PRAIRIE ISLAND NUCLEAR GENERATING PLANT
Docket Nos. 50-282 License Nos. DPR-42
50-306 DPR-60

License Amendment Request Dated July 15, 1996
Moveable Incore Detector Thimble Reduction

Evaluation of Proposed Changes to the Technical Specifications Appendix A of Operating License DPR-42 and DPR-60

Prairie Island
Instrument Thimble Locations
(Map #118-09)

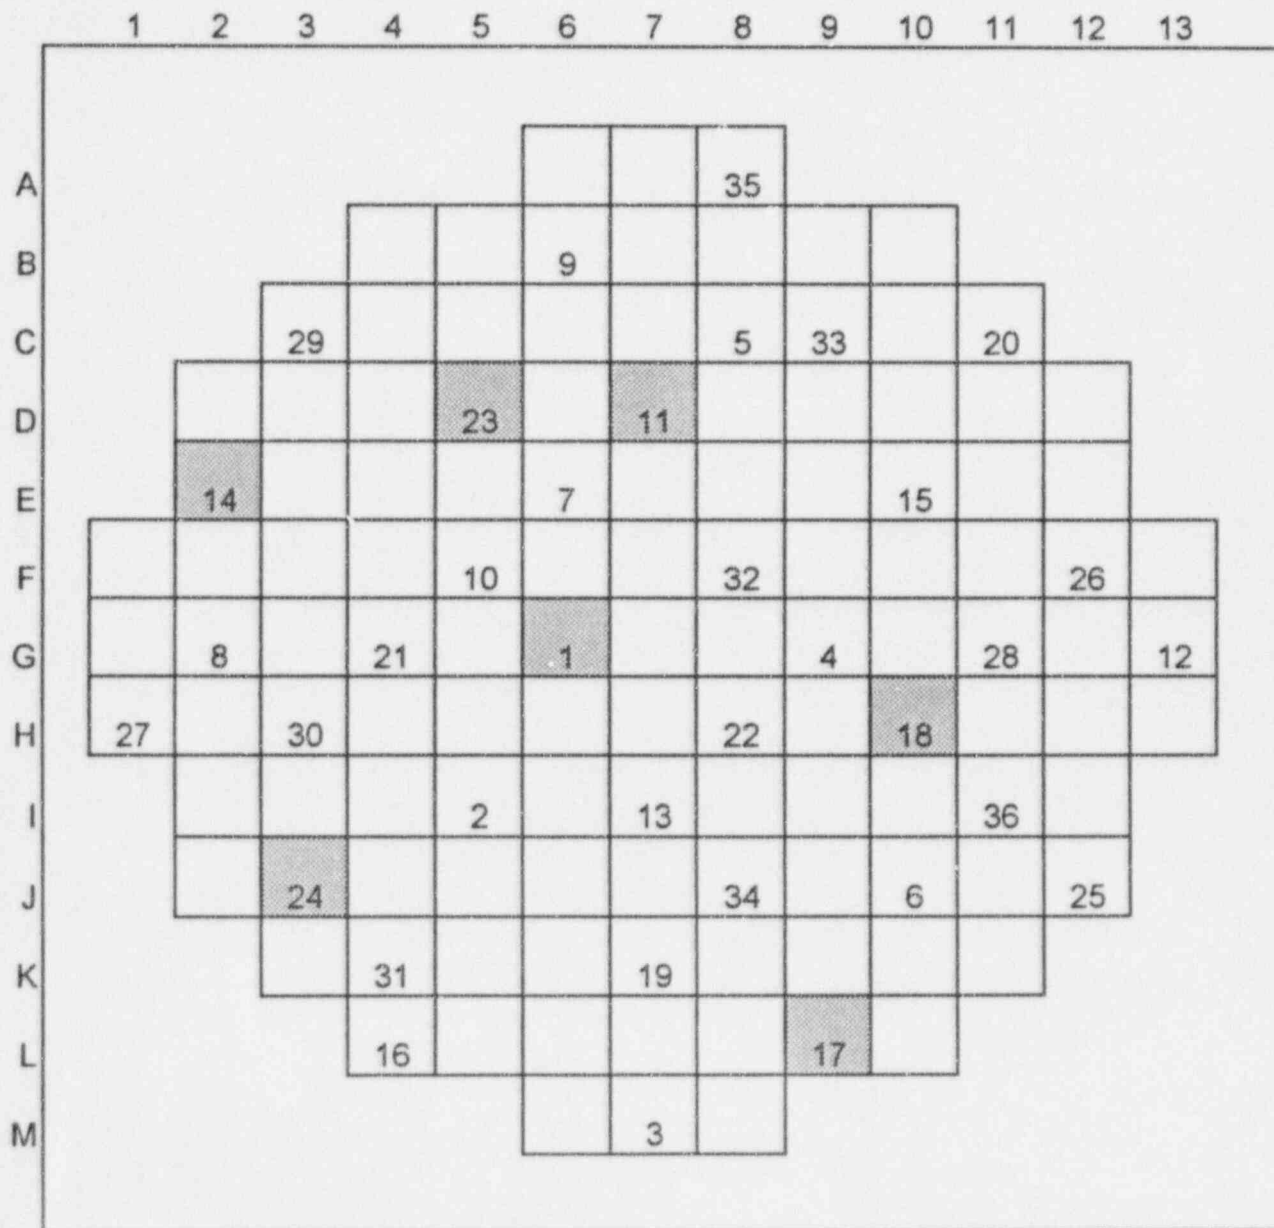
Attachments 2 and 3 to this Exhibit show the thimble locations inaccessible during the performance of flux maps 9 and 10 for Unit 1 Cycle 18. As can be seen from the data above, during the flux map performed on June 21, 1996 only 81% (29 of 36) of the incore thimbles would allow passage of the moveable detectors.

As evidenced by the data above and by Attachments 2 and 3, the location of detector thimbles which are unavailable has changed throughout Unit 1 Cycle 18. However, as can be seen in Attachments 2 and 3, for flux maps 9 and 10 the available detectors were well distributed throughout the core and the thimble coverage was adequate.
